This Service Information bulletin supersedes SI M51 05 15 **dated August 2015.**

Recall Campaign 15V-450: Side Impact Performance

NEW F56 (MINI **Cooper S** Hardtop 2-Door)

GRUSB5115-27

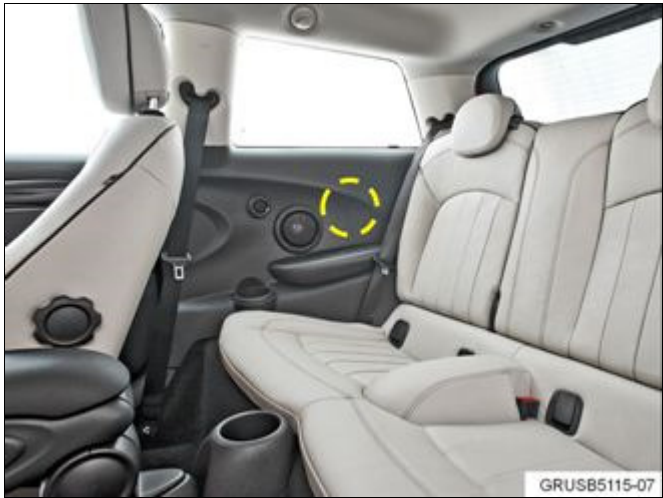
The space between the rear seat left and right interior side panels, and the vehicle body will be modified to increase energy-absorbing performance by installing small structural filler, referred to as a "patch." This modification is not visible to occupants inside or outside the vehicle.

<p style="text-align: right; font-size: small;">GRUSB5115-07</p>	<ul style="list-style-type: none"> • The general area of the repair is circled, with the side panel in position. The passenger side of the vehicle is shown; the driver side is also affected. • Remove the rear right and left hand side trim panels per Repair Instructions 51 43 002.
--	--

- Clean the area where the patch will be installed.
- Install the self-adhesive foam rubber (patch) to both left and rear panels as indicated by the arrow.
- Install both the rear right and left hand side trim panels per Repair Instructions 51 43 002.
